IEEE802.3cg TF

TIS scrambler proposal

March 28th, 2018

Figure TBD#1

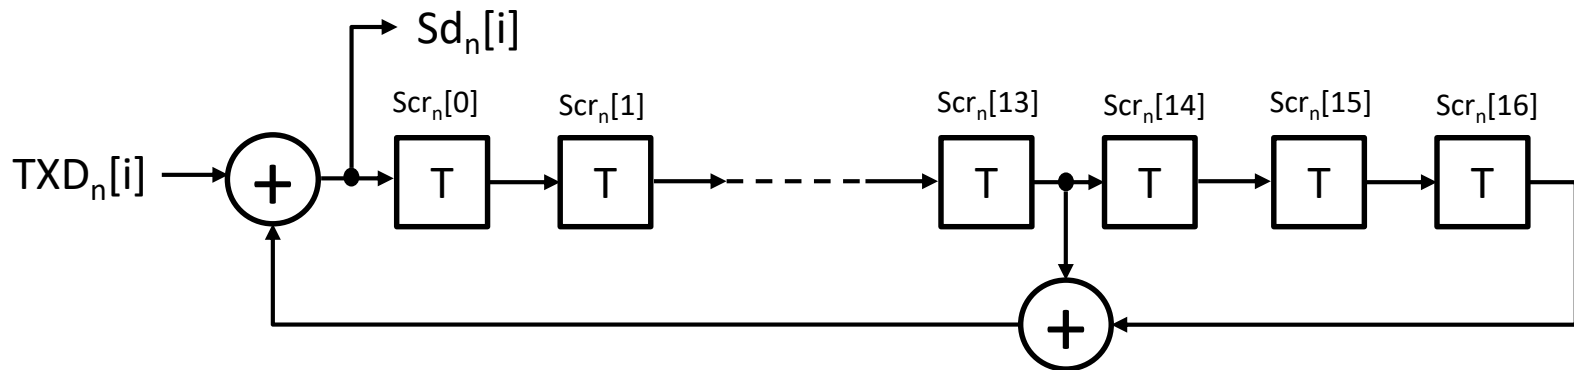
- **147.2.2.5 Self-synchronizing scrambler**

The PCS Transmit function shall implement multiplicative scrambling using the following generator polynomial:

$$g(x) = 1 + x^{14} + x^{17}$$

An implementation of self-synchronizing scrambler by linear-feedback shift register is shown in figure TBD#1. The bits stored in the shift register delay line at time n are denoted by $Scr_n[16:0]$. At every MII clock cycle, for each bit of $TXD[3:0]$ the scrambler is advanced by one bit, and the output bit $Sd_n[i]$ represented by the exclusive OR of $Scr_n[13]$, $Scr_n[16]$ and $TXD[i]$ is shifted in as $Scr_{n+1}[0]$, with i ranging from 0 to 3 (i.e. LSB first). The scrambler is reset upon execution of the PCS Reset function. If PCS Reset is executed, all bits of the 17-bit vector representing the self-synchronizing scrambler state are arbitrarily set. The initialization of the scrambler state is left to the implementer. In no case shall the scrambler state be initialized to all zeros.

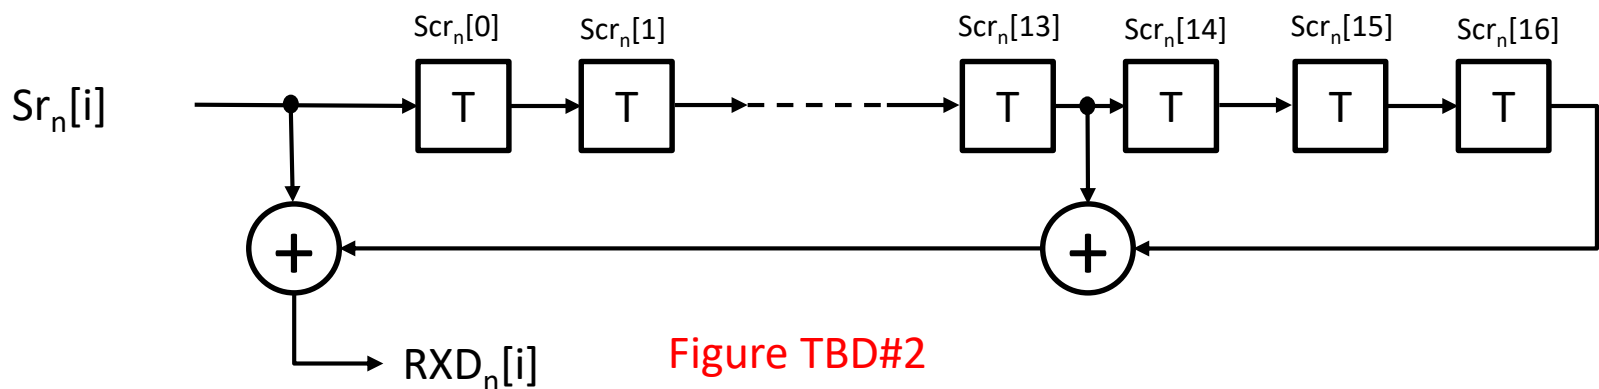
- **147.2.3.1 Variables**

precnt counter for preamble regeneration

Figure 147-5—PCS Receive state diagram (1 of 2)

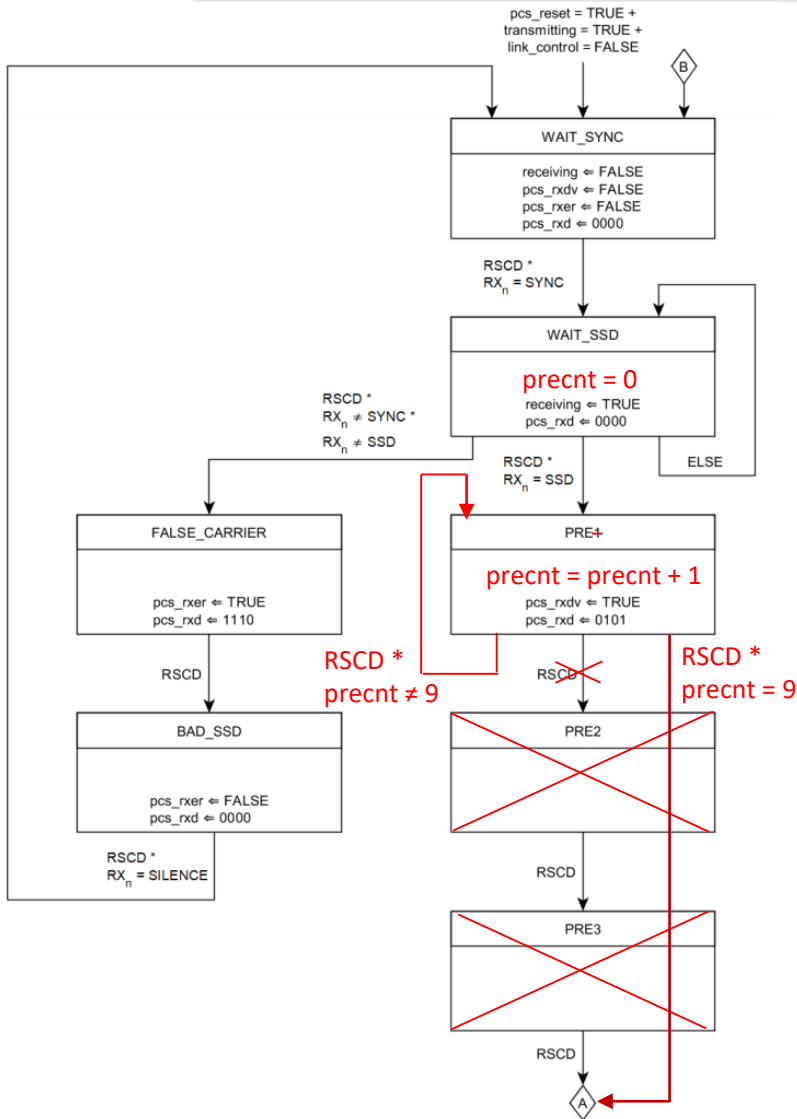
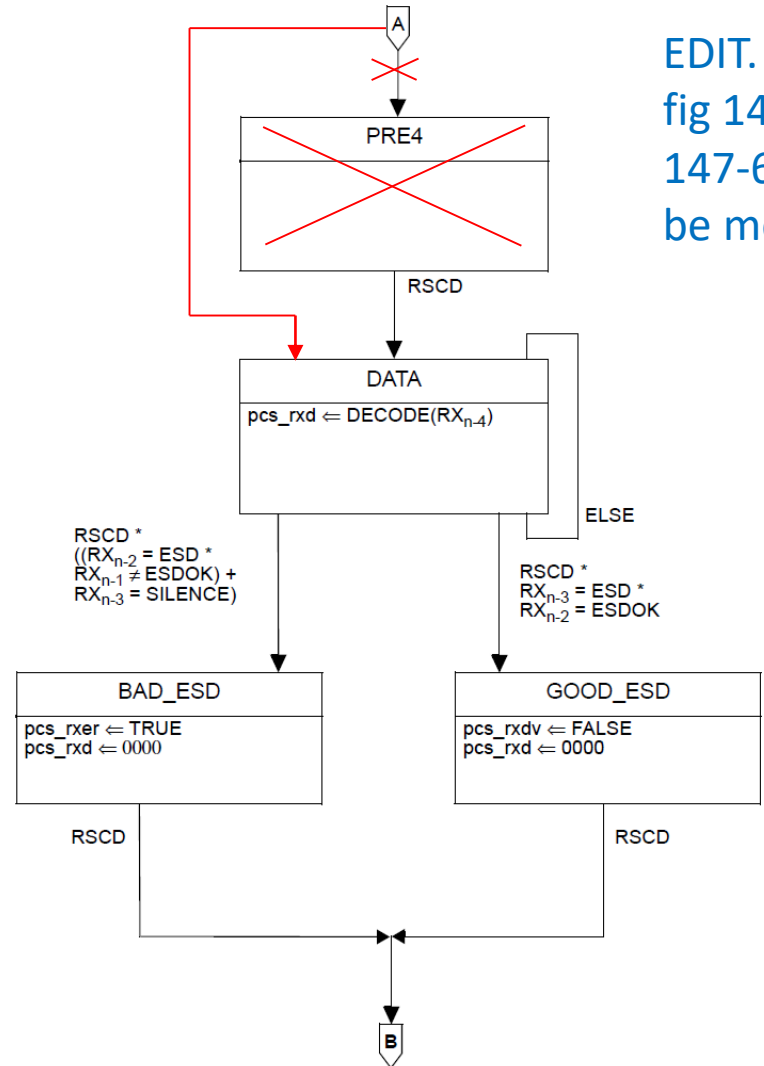
EDIT. NOTE:
fig 147-5 and
147-6 could
be merged
